SUBJECT: PALO VERDE NUCLEAR GENERATING STATION, UNITS 1, 2, AND 3 -
ISSUANCE OF AMENDMENTS ON FUEL STORAGE POOL CAPACITY (TAC
NOS. MA5685, MA5686 AND MA5687)

ATTACHMENT TO LICENSE AMENDMENT NOS. 125, 125, AND 125
FACILITY OPERATING LICENSE NOS. NPF-41, NPF-51, AND NPF-74
DOCKET NOS. STN 50-528, STN 50-529, AND STN 50-530

SAFETY EVALUATION BY THE OFFICE OF NUCLEAR REACTOR REGULATION
RELATED TO AMENDMENT NO. 125 TO FACILITY OPERATING LICENSE NO. NPF-41,
AMENDMENT NO. 125 TO FACILITY OPERATING LICENSE NO. NPF-51,
AND AMENDMENT NO. 125 TO FACILITY OPERATING LICENSE NO. NPF-74
ARIZONA PUBLIC SERVICE COMPANY, ET AL.
PALO VERDE NUCLEAR GENERATING STATION, UNITS 1, 2, AND 3
DOCKET NOS. STN 50-528, STN 50-529, AND STN 50-530

Figure 3.7.17-1
ASSEMBLY BURNUP VERSUS INITIAL ENRICHMENT
for
Region 2

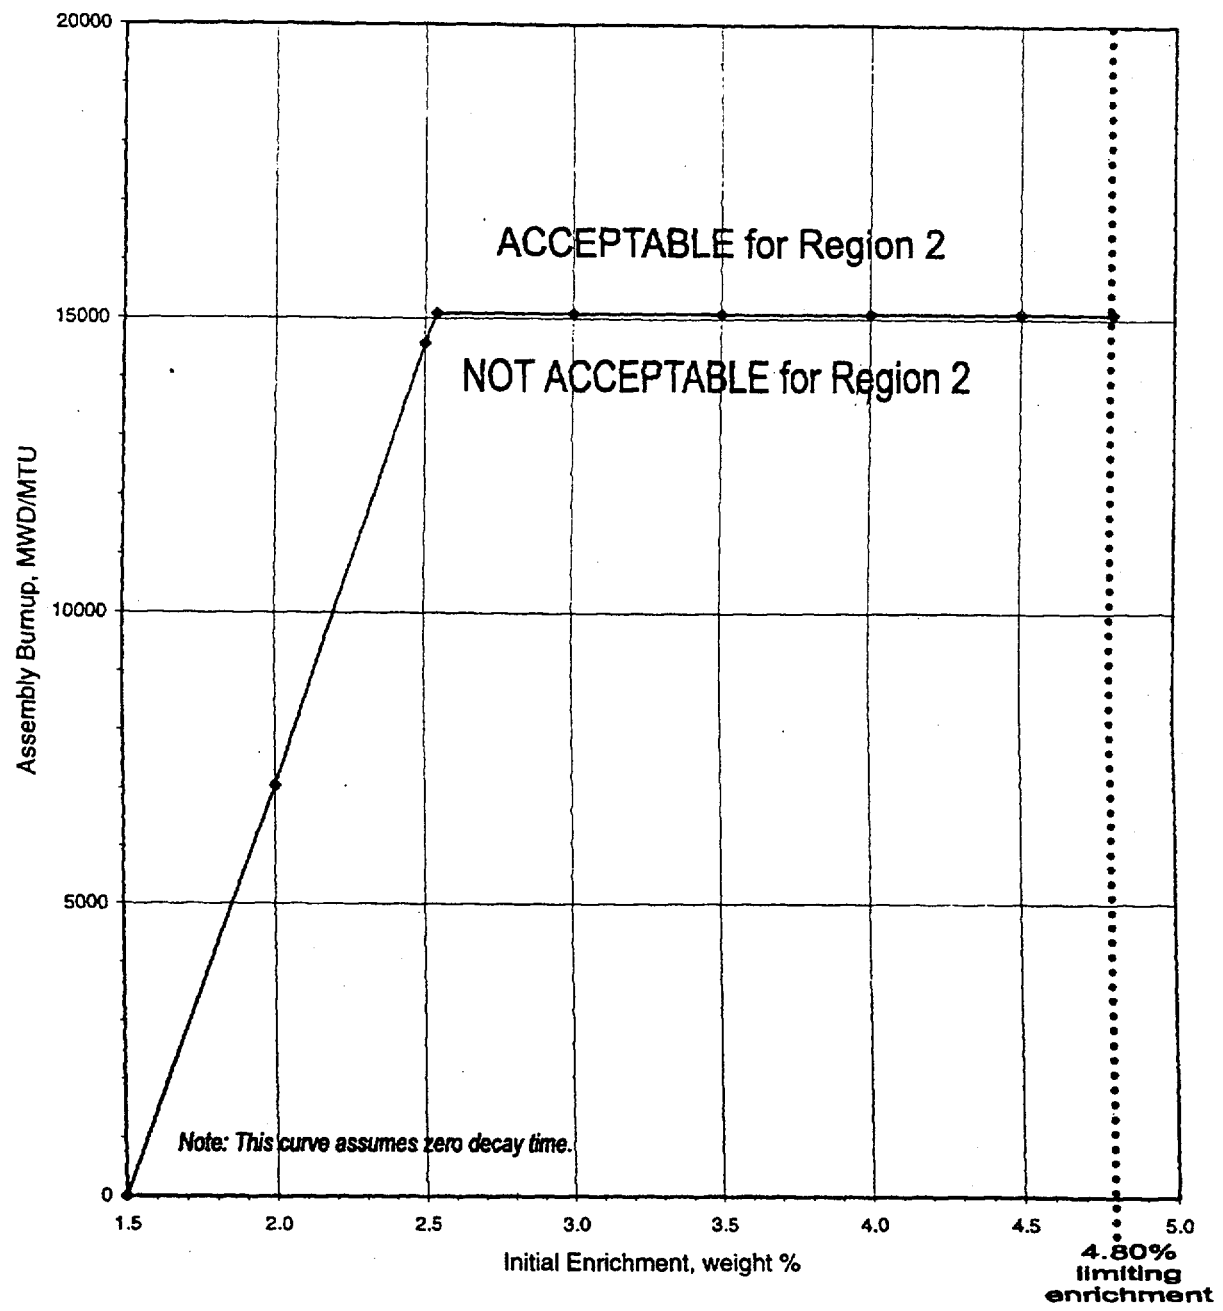
LCO 3.7.17 The combination of initial enrichment, burnup, and decay time of each fuel assembly stored in each of the four regions of the fuel storage pool shall be within the acceptable burnup domain for each region as shown in Figures 3.7.17-1, 3.7.17-2, or 3.7.17-3, and described in Specification 4.3.1.1.

The licensee proposes to modify TS 3.7.15, "Fuel Storage Pool Boron Concentration," to make it applicable whenever any fuel assembly is stored in the fuel storage pool. TS 3.7.17, "Spent Fuel Assembly Storage," would be revised to include decay time along with modified initial enrichment and burnup requirements to determine the region in which each fuel assembly can be stored. In addition, the maximum radially averaged enrichment allowed in the figures would be increased from 4.3 to 4.8 w/o U-235. TS 4.3.1, "Criticality," would be revised to require a k_{eff} less than 1.0 (including all biases and uncertainties) with the spent fuel pool fully flooded with unborated water and a $k_{\text{eff}} \leq 0.95$ (including all biases and uncertainties) with the spent fuel pool flooded with water borated to 900 ppm. These proposed TS changes are consistent with the revised criticality analysis evaluated above. Based on this consistency and on the use of approved methodology, the staff finds these TS changes acceptable.

Figure 3.7.17-3
ASSEMBLY BURNUP VERSUS INITIAL ENRICHMENT
for
Region 4
(at decay times from 0 to 20 years)

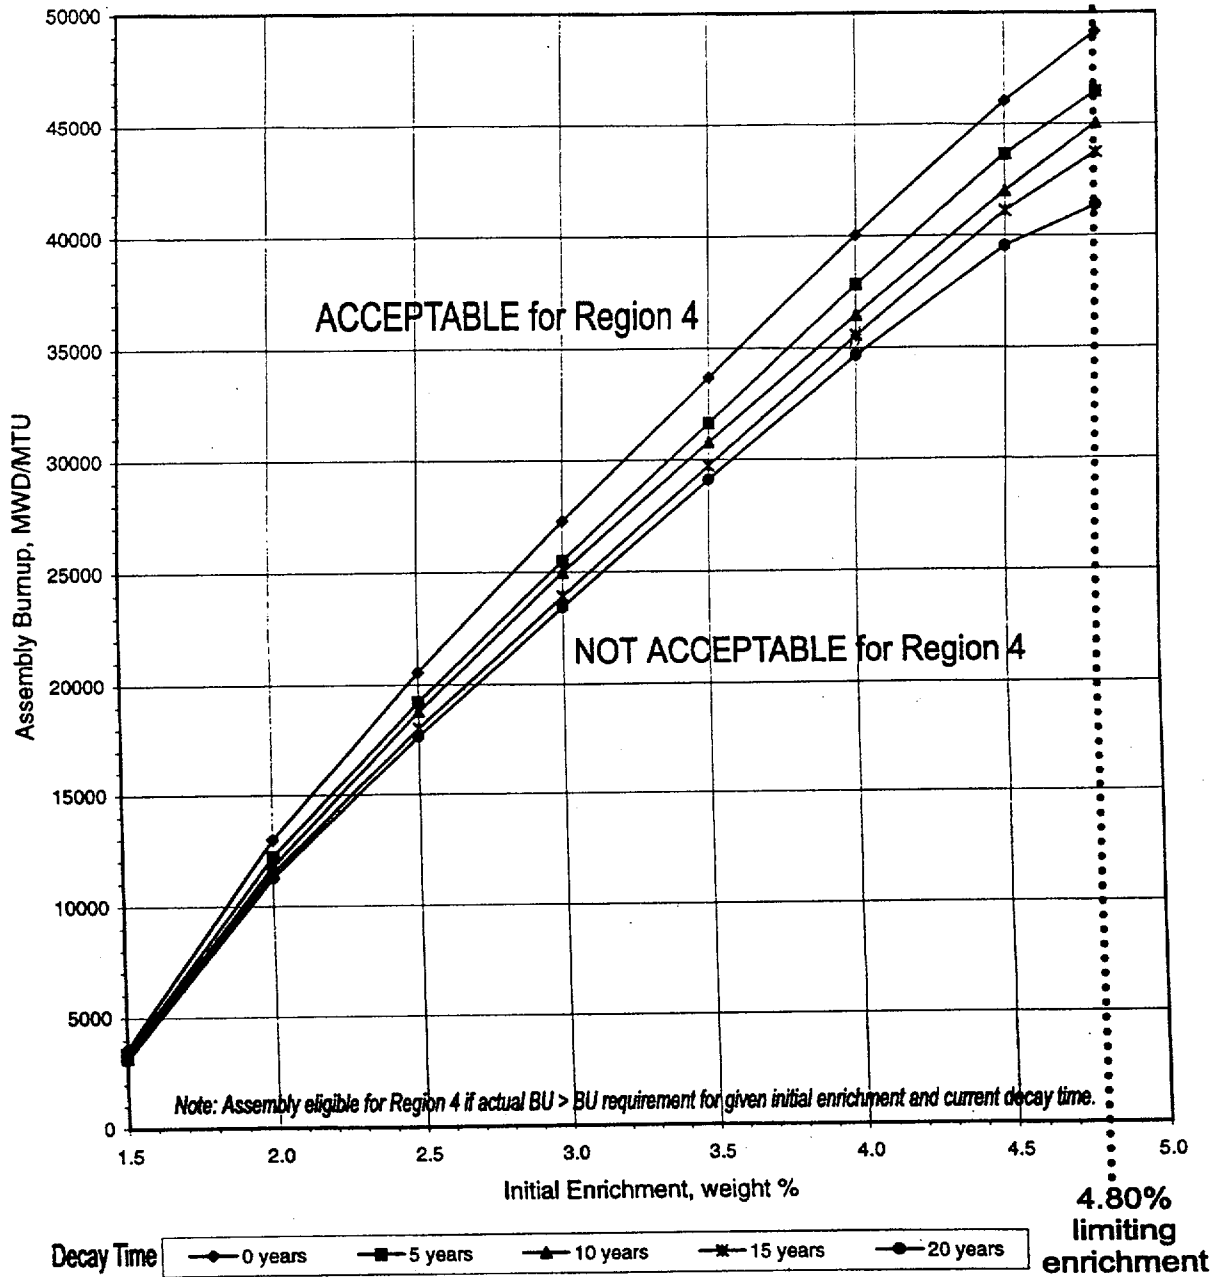
- h. Region 4: Fuel shall be stored in a repeating 3-by-4 storage pattern in which Region 2 (two-out-of-twelve) assemblies and Region 4 (ten-out-of-twelve) assemblies are mixed as shown in Section 9.1 of the UFSAR. Only fuel that qualifies to be stored in Region 4 in accordance with Figure 3.7.17-3 shall be stored in Region 4.
